IN THE UNITED STATES PATENT AND TRADEMARK OFFICE

Title: "Backpressuring Using A Serial Bus Interface And A Status Switch Cell"  
(As Amended)

Atty. Doc. No.: AZA-003-7D/2001-P010

**PRELIMINARY AMENDMENT**

FIG. 52

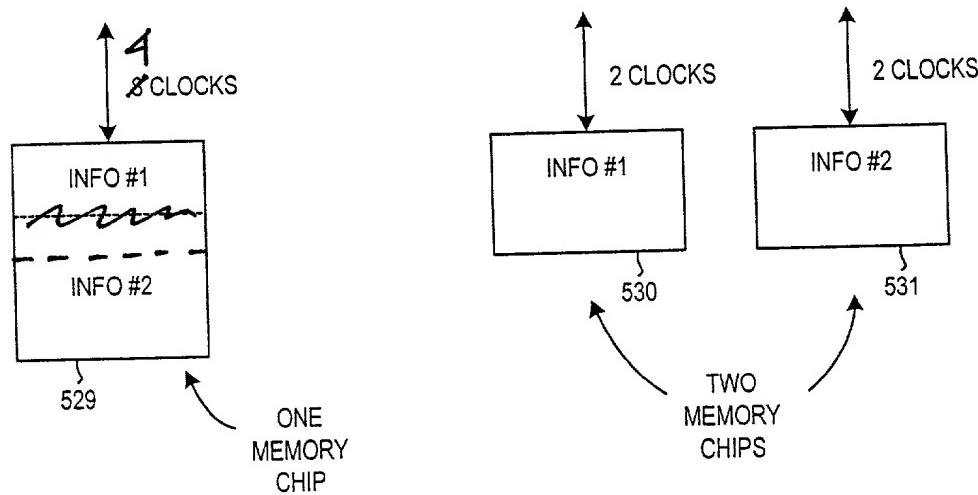
A minor error in Figure 52 is corrected. A copy of Figure 52 with the correction indicated in red is attached. In reviewing the correction, the Examiner's attention is direct to page 59, line 22 of the specification through page 60, line 21 and the corrections made to that text (see below). Review and approval of the correction by the Examiner is requested. No subject matter is added by the correction, nor is it the intent of Applicants or the undersigned that any subject matter be added.

A copy of Figure 52 with the corrections indicated in red is attached.

four clock periods. In the example to the left of Figure 52, each piece of information can be accessed in two clock periods. Both pieces of information are stored in the same external memory device requiring one to be accessed before the other. A total of four clock periods is therefore required to access both pieces of information.

[eight] four clock periods. In the example to the left of Figure 52, each piece of information can be accessed in two clock periods. Both pieces of information are stored in the same external memory device requiring one to be accessed before the other. A total of four clock periods is therefore required to access both pieces of information.
